ZX-B183-1

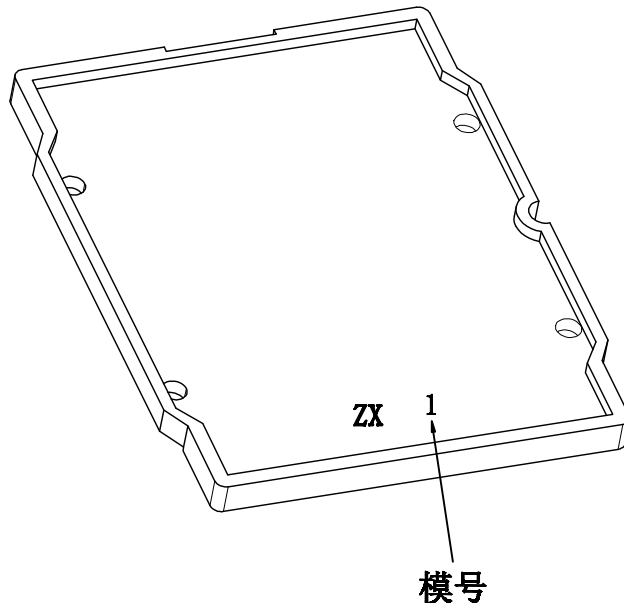
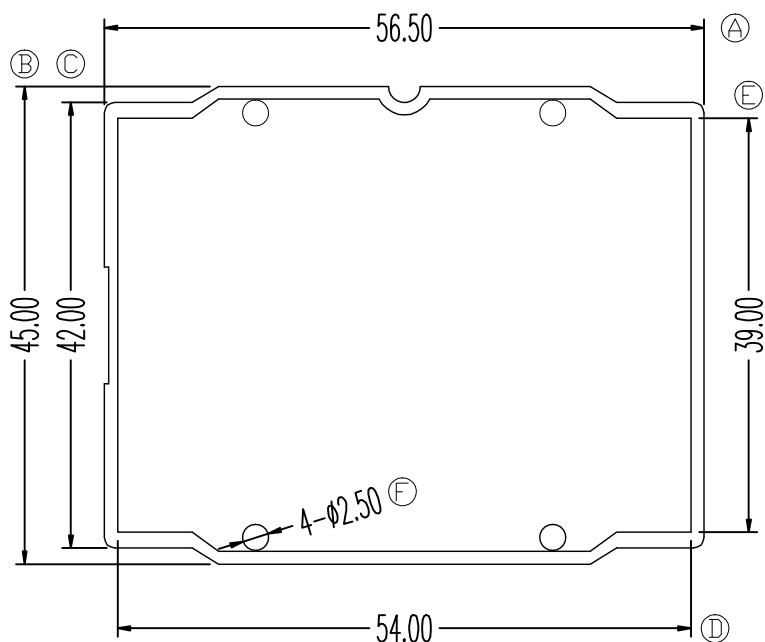
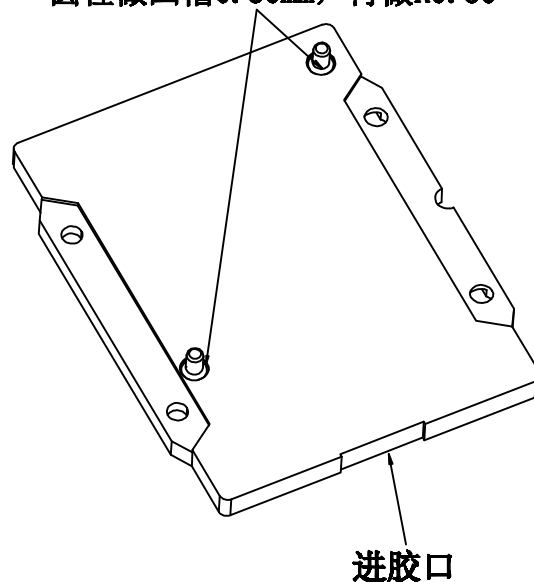
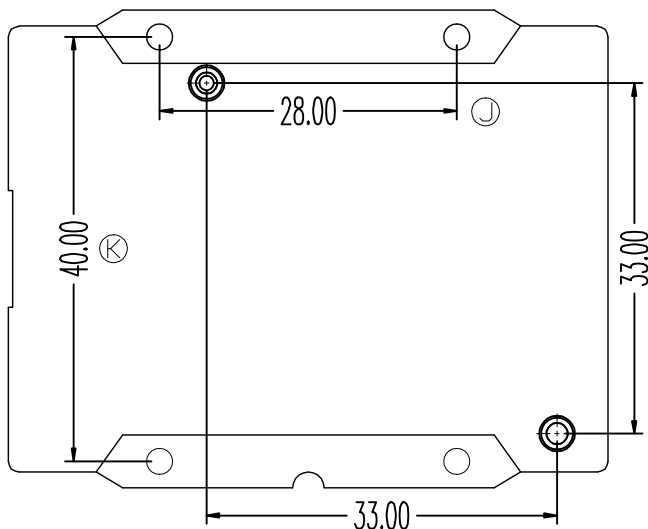
圆柱做凹槽0.30mm，再做R0.50

项次	REVISIONS	REC.	DATE	项次	REVISIONS	REC.	DATE
1	① 尺寸由57.00改为56.50mm		2024.08.29	4			
2	增加两个圆凸点		2024.08.29	5			
3	因圆柱容易断，圆柱做凹槽0.30mm，再做R0.50		2024.10.23	6			
DRAWN & DRAFTED BY	LIU WEI QIANG	TOLERANCES	ANGLE:	TITLE: PQ53 DZ			
CHECKED & APPROVED BY	LIN JUN	0<L≤4 ±0.1 4<L≤16 ±0.2 16<L≤63 ±0.3	UNIT: MM	BOBBIN MATERIAL:	PM-9823	UL REC.	UL 94V-0
智信电子塑胶有限公司			SCALE:	PIN MATERIAL:		PIN TENSION LOAD:	
ZXE ZHI XIN ELECTRONICS PLASTIC CO., LTD.				DATE:	2024.10.23	DRAWING NO.	ZX-B183-1
TEL:0769-86389901-2 FAX:0769-86389903						REV.	A03
